SERVICE BULLETIN

NUMBER: 03-70-12R
DATE: 12/13/12
REVISED: 01/15/14

SUBJECT: Repair Procedure for High-Pitched Sound from Extension Housing Area Using Latest Generation Production Parts

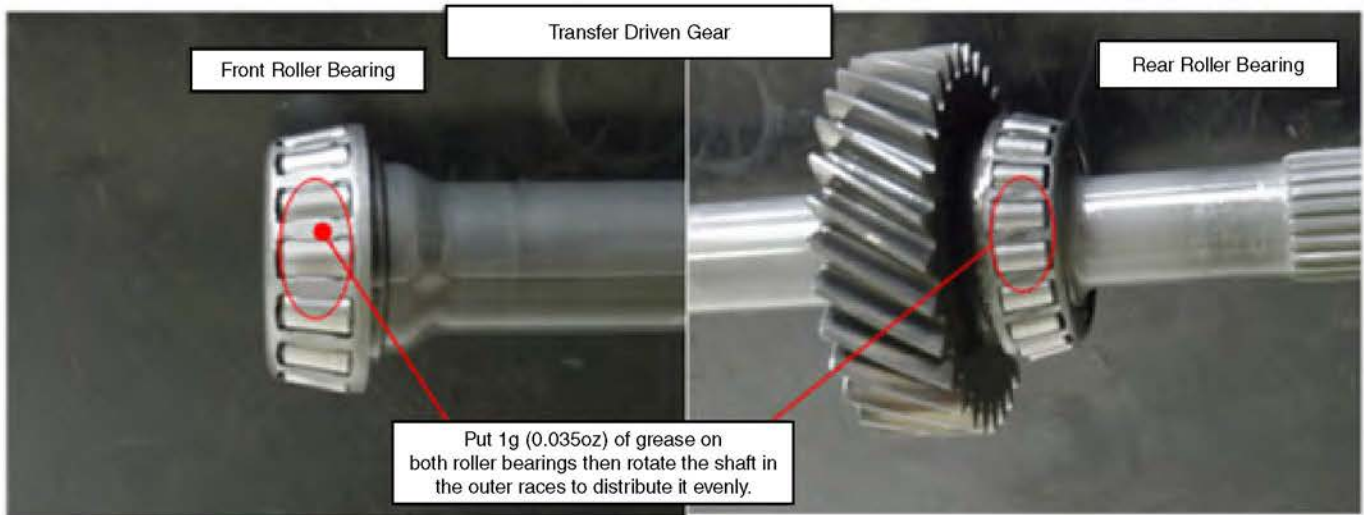
NOTE: When replacing the extension case, the output oil seal, p.n. 806735210 must be replaced. If the transmission number is prior to 5588478, and you are replacing the extension case, shorter case bolts, p.n. 800610940, (quantity 9) must also be installed due to the thinner retaining bolt boss areas of the replacement extension case (16mm vs. 20mm) as shown in the photos below.

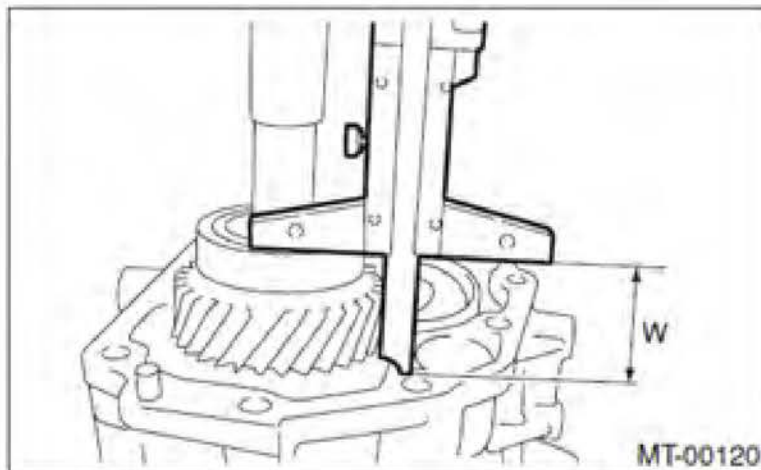
- Measure height “W” between transfer case sealing surface and taper roller bearing outer race on the transfer driven gear.

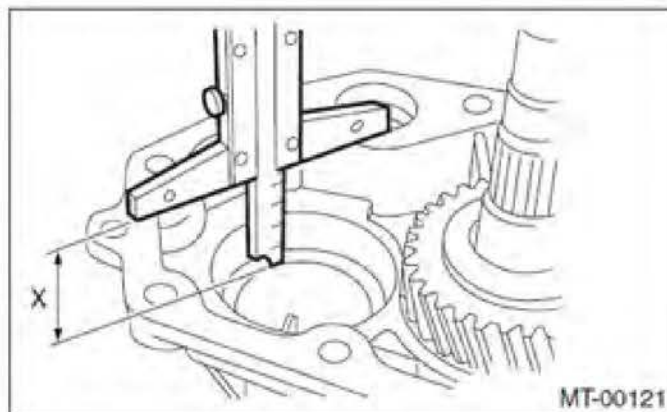
- With the bearing outer race, dish plate and thrust washer removed, measure depth “X” of the bearing bore of the extension case.

- Calculate the required thrust washer thickness “T” using the revised formula below:

$$T = X - W - (1.715 \text{ to } 1.765 \text{ mm (0.0686 to 0.0706)}).$$

NOTE: This formula has been revised from the formula shown in the Service Manual to work with the new dish plate and extension case assembly.

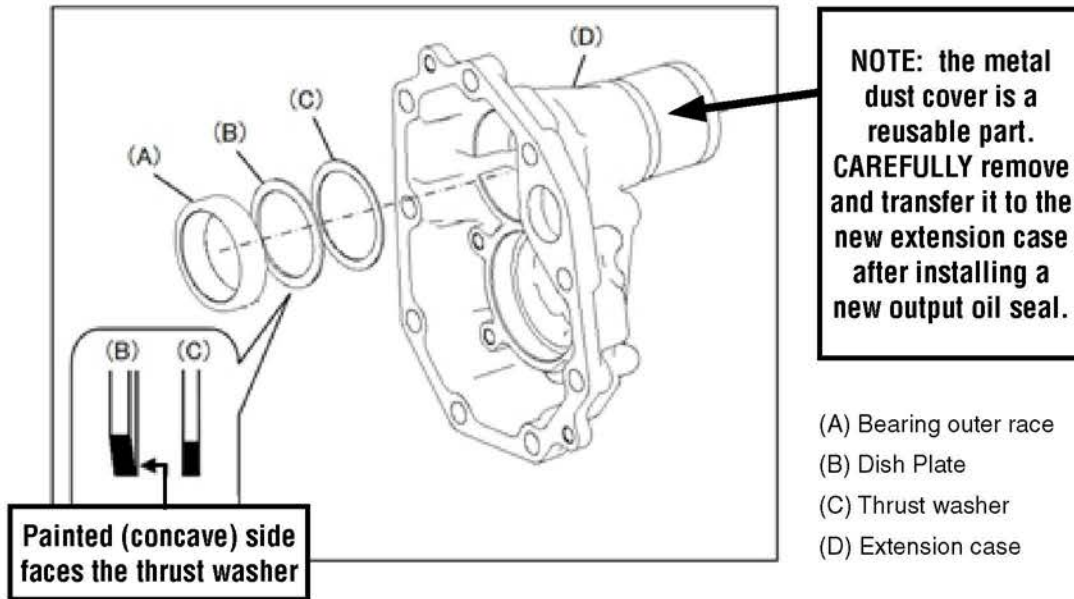
- Once the proper thrust washer has been selected, assemble the new extension case as shown in the illustration below.

- Install a new output oil seal before transferring the original metal dust cover over to the new extension case.
- Follow the procedure in the applicable Service Manual for re-installation of the new extension case assembly to the transfer case.
